Engineering Change Notice

Title	ART2000 T4 Connector panel Rib
ECN Number	ECN-142
Equipment	ART 2000 T4 (4 modules) frame serial A2F 001 till A2F 250
Author	J.B.Toby
Drawing Number	
Date	18-10-2001

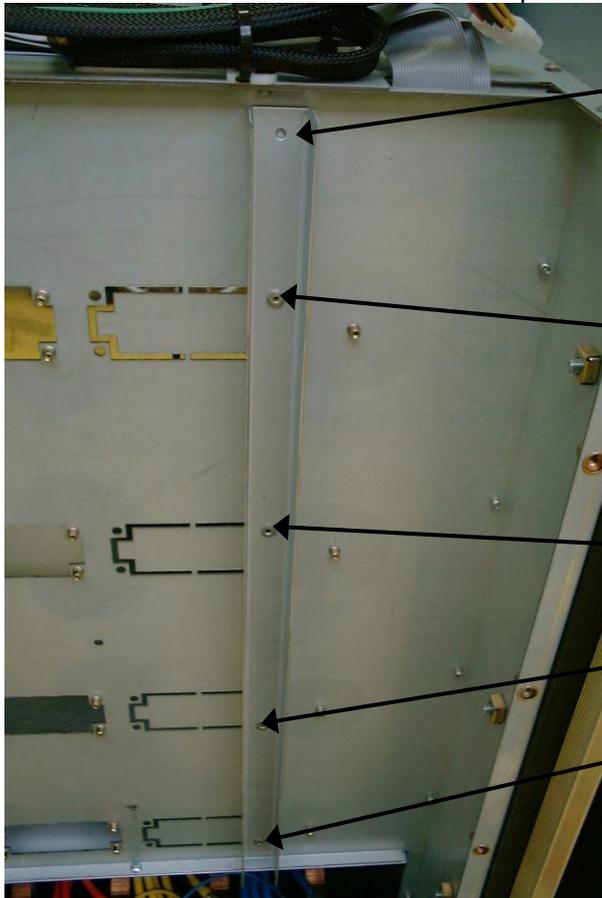
Reason for ECN	Some racks do not connect the module to the frame
Special Parts required	Connector panel rib kit avolites part number 32-02-9002
Special Tools required	Rivet gun/PZ02 screw driver/ 4mm metal drill

- Power down and remove the mains connection from the Rack
- Remove the module (unscrew the two M6 Pozi screws on the module)
- Remove the patch output panel (the panel with the socapex or harting connectors)
- Fit the Rib to the back of the connector panel using the four supplied rivets.

To be drilled **after** the other 4 holes have been riveted

Bay 1 hole, rivet only

Bay 2 hole, rivet only

Bay 3 hole, rivet only

Bay 4 hole, rivet only

- Drill the 5th top hole from the back with a 4mm drill
 - Rivet the 5th hole
- Alternatively M4x16 screws and Nyloc nuts can be used instead of the 4mm rivets
